**KNOXVILLE HISTORIC ZONING COMMISSION
STAFF REPORT - CERTIFICATE OF APPROPRIATENESS APPLICATION**

PROPERTY ADDRESS: 1601 Forest Ave 37916

FILE NO.: 2-F-19-HZ

LEVEL OF WORK: Level II. Demolition and reconstruction of addition

West Side:

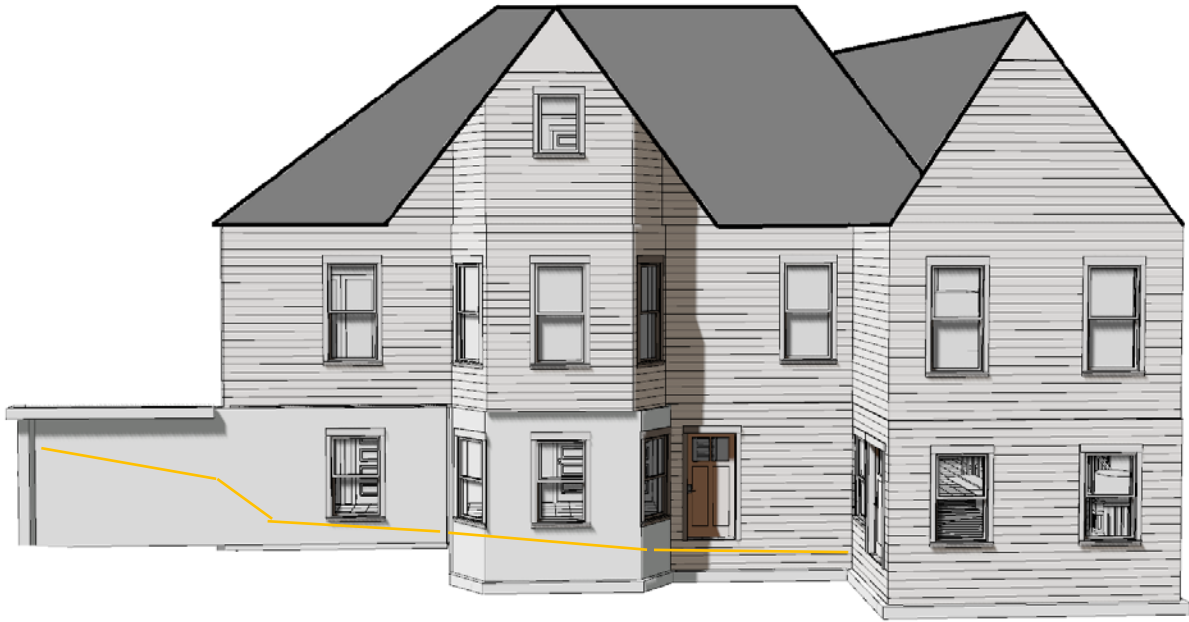
8) Replacing the demolished set of twin windows on the west projecting bay with a single window is not appropriate.

The two windows in the gable will reduce to one centered window for the kitchen. We can install a full height window and block off the lower half to make it more consistent height wise with the rest of the house.

3. The demolished walls on the east and west sides are to be reconstructed with the condition that the window openings match the original size and locations including the replication of the original set of twin windows on the west side. The original fascia and corner trim is to be replicated.

East Side:

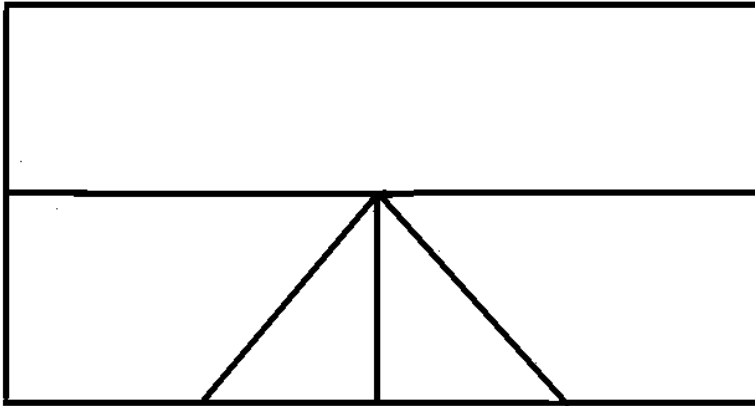
7) Relocating the basement door on the east side to the left by 18 inches does not have significant impact; however, the window above it should be located as closely to the middle of this wall section as possible in order to replicate the original placement.

The door on the East side will need to move 18" to the left to accommodate the firewall which must be built inside the house to meet building code requirements. The gables of the addition will be of a shake design.

The yellow line is the dirt line. It currently ranges from 18" down to 50" on the brick under the porch, continues sloping downwards from 50"-78" to the left side of the bay, and then from 78" down to 86" at the door up to the addition.

7. The window opening on the east side must be located as closely to the middle of this wall section as possible in order to replicate the original placement.

8. The ground level must be restored at least as high along the east and west facades as shown in the submitted and approved elevation drawings.

1601 Forest Elevations - West

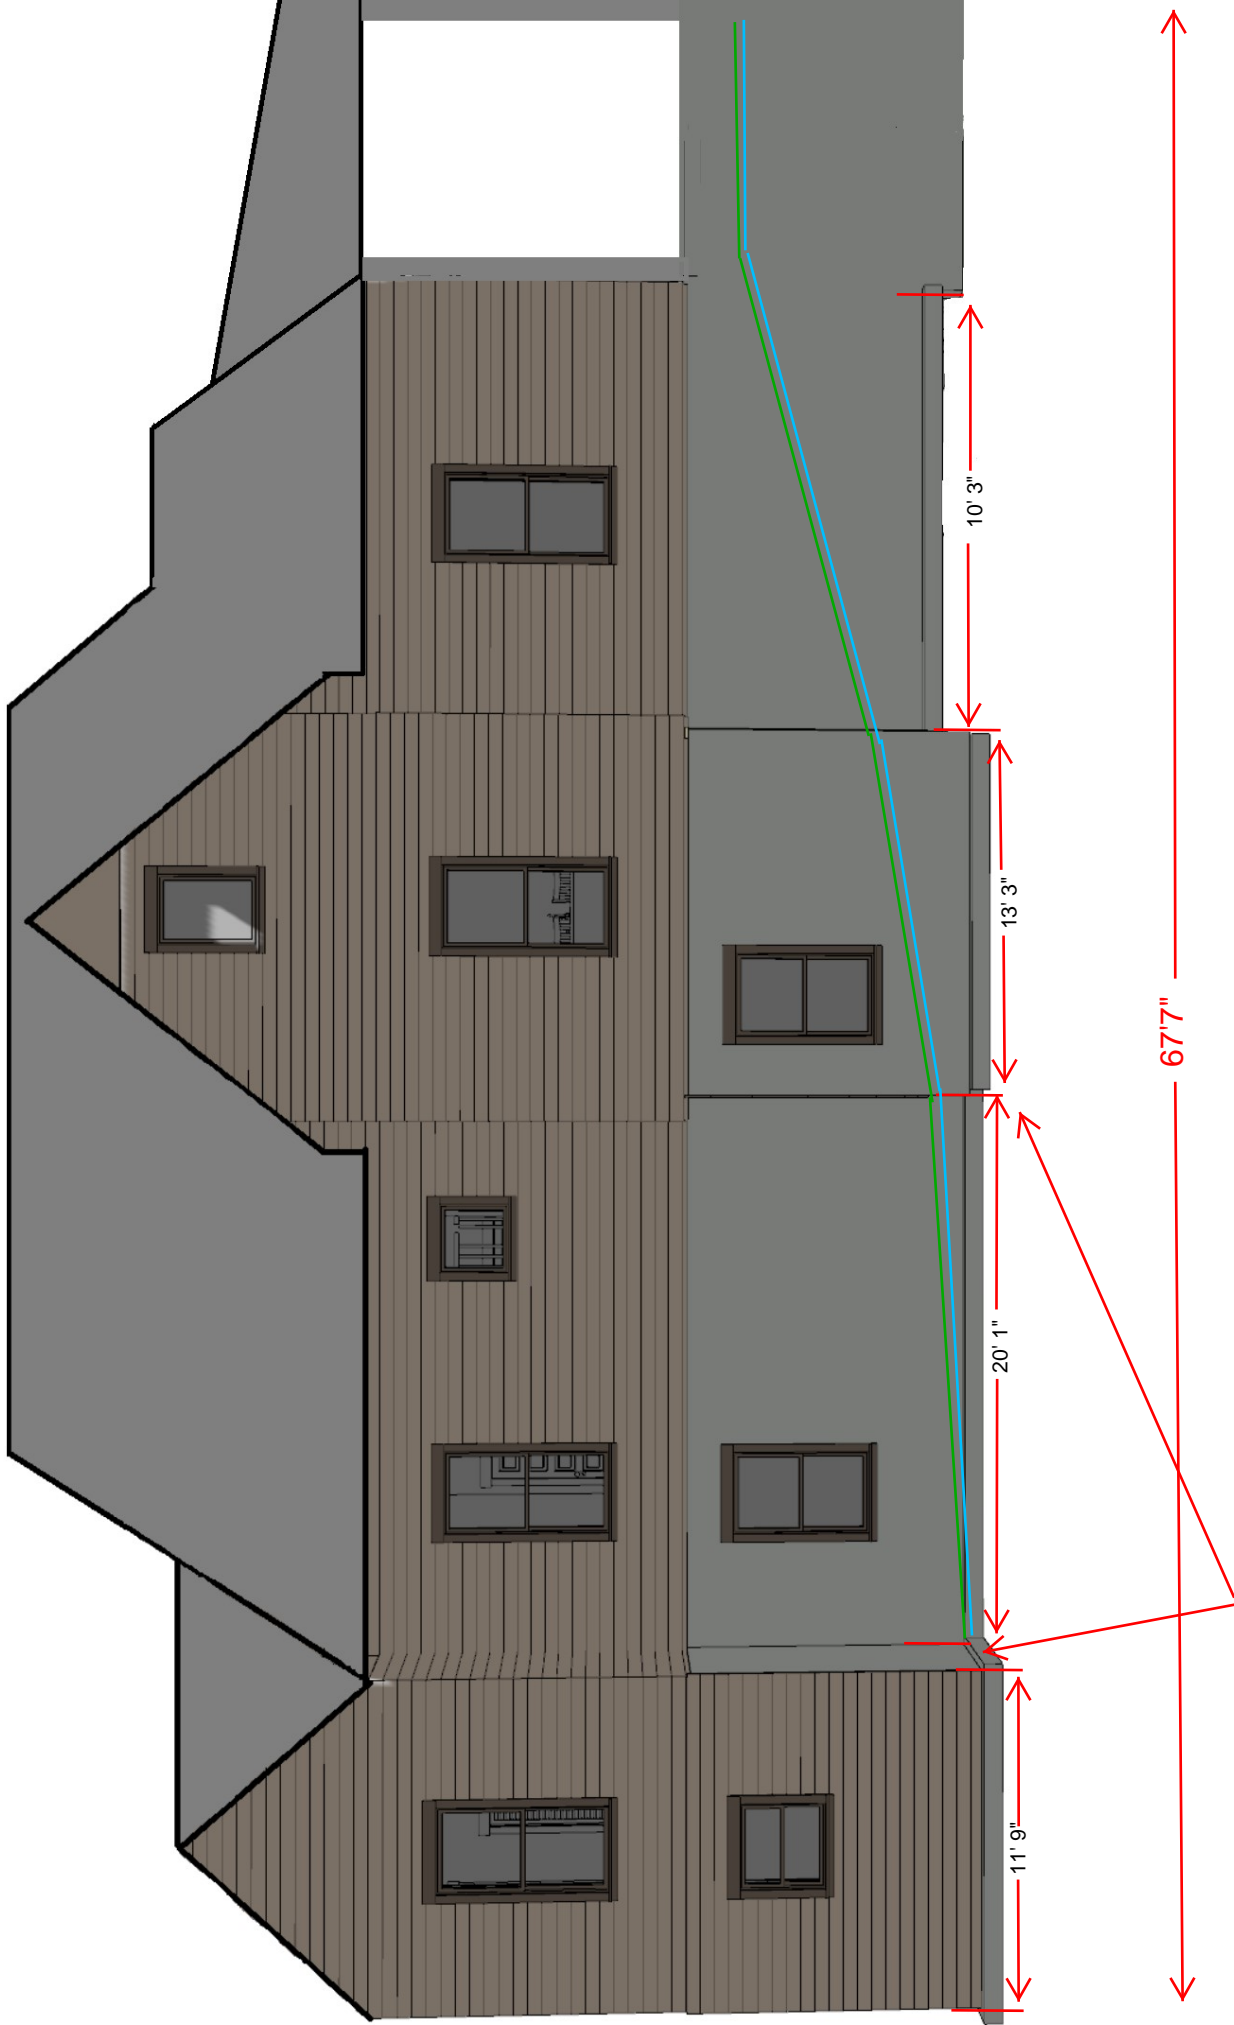
- 4) The proposed 4 windows double-hung windows symmetrically placed on the 16th Street-side, and relocating the door to face the front will somewhat improve the appearance of the addition. It is proposed to be a few inches smaller in footprint given that it will required to be to be pulled back off of the west and south property lines. However, in order for the addition to be sufficiently distinguished from the main house, a minimum of a one-foot offset from the NW corner of the main house, as shown, will be necessary.

Offset is 1', this is a 6" reduction on addition due to building code requirements
